ADDENDUM NUMBER 1

DATE: October 24, 2012

PROJECT: Old North Durham Park Infrastructure Improvements

CONTRACT NUMBER: SD-2012-05

BACKFLOW ASSEMBLY IN ENCLOSURE  
 NTS

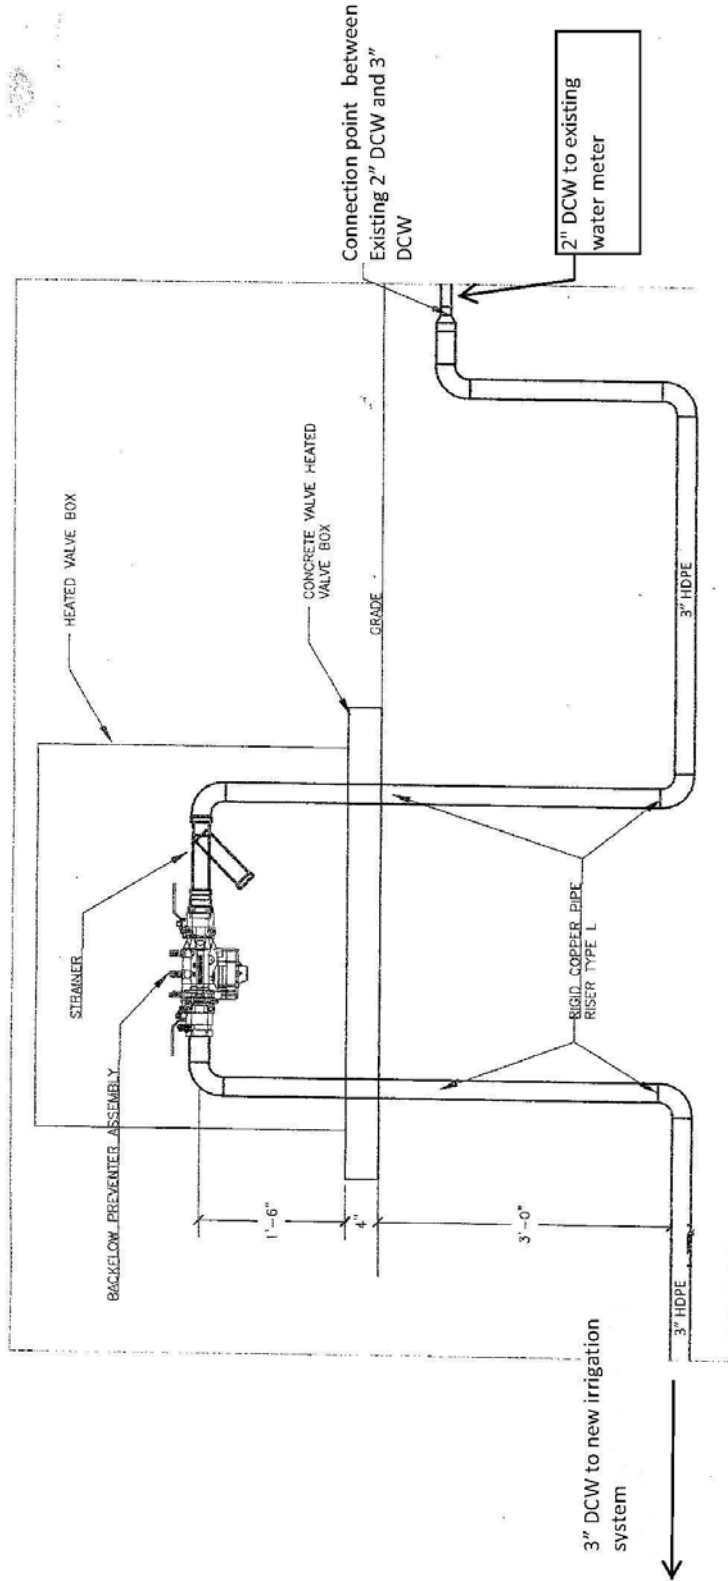
11. Paragraph 3.12, replace the entire detail for the Backflow Assembly in Enclosure with the detail on the following page.

1. Contractor to verify the waterline sizes and the size of the backflow preventer, based on the requirements of the irrigation system.
2. A reduced pressure zone assembly shall be installed to prevent back siphonage and the backpressure of hazardous materials into the potable water supply. The assembly shall consist of a pressure differential relief valve located in a zone between two positive seating check valves. Back siphonage protection shall include the provision to admit air directly into the reduced pressure zone via a separate channel from the water discharge channel, or directly into the supply pipe via a separate vent.

3. The assembly shall include two tightly closing shutoff valves before and after the assembly, test cocks and a protective strainer upstream of the No. 1 shutoff valve.

4. The assembly shall meet the requirements of ASSE STD. 1013; AWWA STD. C-511-92 CSA B64.4; FCCCHR of USC Manual Section 10. Listed by IAPMO (UPC), SBCCI (Standard Plumbing Code).

5. The assembly shall be a Watts Regulator Company Series 909QTS or equal by FEBCO, Hersey, Wilkins, or Contraco.

1. Slab size is 6" larger than the length and width of the enclosure, and a minimum thickness of 4" above grade.
2. Heat is provided by a 90W, 120V single phase heat trace cable. Plugged into GF receptacle circuit.
3. Contractor is to verify the internal minimum dimensions and is responsible for verifying that the sizes listed will allow service clearances after backflow preventer assembly is installed.
4. Insulation is spray-applied polyisocyanurate foam (structural unicellular insulation) 1.5" thick to provide a minimum R Value of 8.
5. Insulated enclosures will be designed to protect to -30 degrees F when provided with heat.
6. Material of construction - Fiberglass. Color - Dark green.
7. Heated valve box must meet standards ASSE 1060.
8. Heated valve box shall be Wattsbox, Hotbox, Aquashield or equal.
